Petro Operating Company, LLC
LG Everist Pad
Location # 318924
NWNW Section 30, T1N R66W
Fort Lupton, Colorado

CPW CONSULTATION SUMMARY

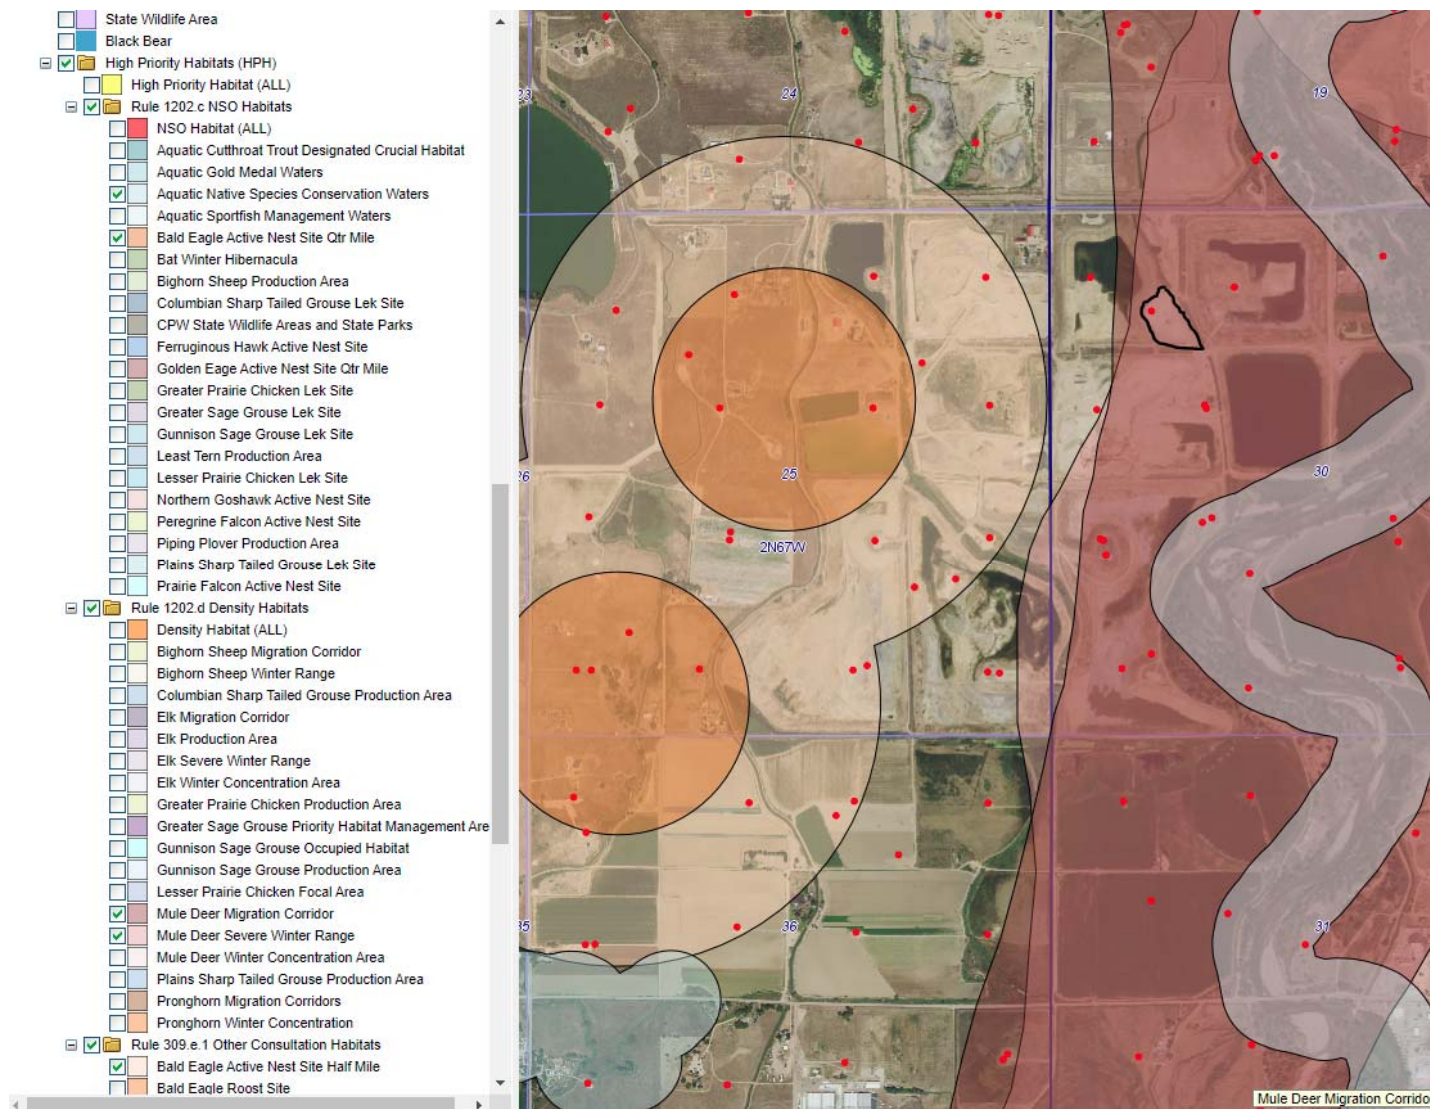
Thank you for getting back with me so quickly. I really hope that this is the case, and that we are not within a HPH. However, the map layers I show on my COGCC webmapper do have the "Mule Deer Migration Corridor" and "Mule Deer Severe Winter Range" overlapping our location (in black below). Could you all please confirm if these do not apply in our case? It seems to me that Rule 1202.d. applies here, but I might be missing something. It certainly would make our lives easier if we do not qualify as a HPH location.

Even though your proposed location is located within those two HPH mule deer polygons (and initially subject to 1202.d), the habitat has been removed by the existing sand and gravel operation. Therefore, CPW waives any direct or indirect mitigation associated with developing this pad.

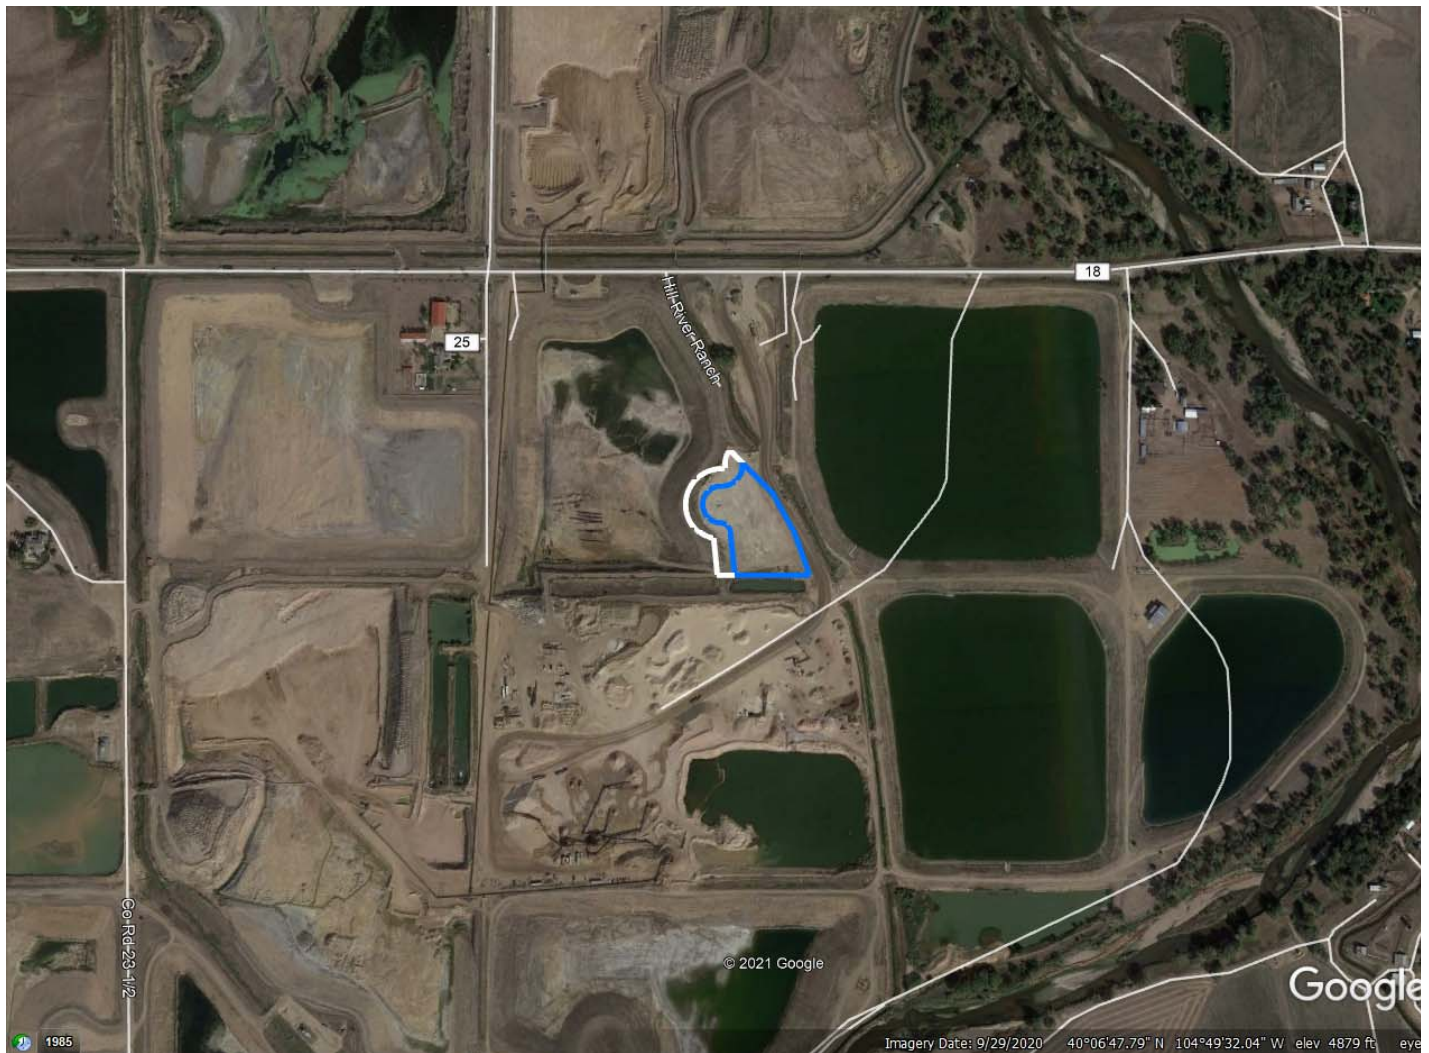
This location falls within the Mule Deer Migration Corridor and Mule Deer Severe Winter Range HPHs. It is roughly 1700' from the edge of the location to the edge of the Aquatic Native Species Conservation Waters at the South Platte.

After talking with Chris and viewing the [COGCC webmapper](#) for your location (see screenshot below), we determined that your site is not within a High Priority Habitat. Therefore, no Wildlife Mitigation Plan or direct/indirect mitigation fees/acres will be required of this project.
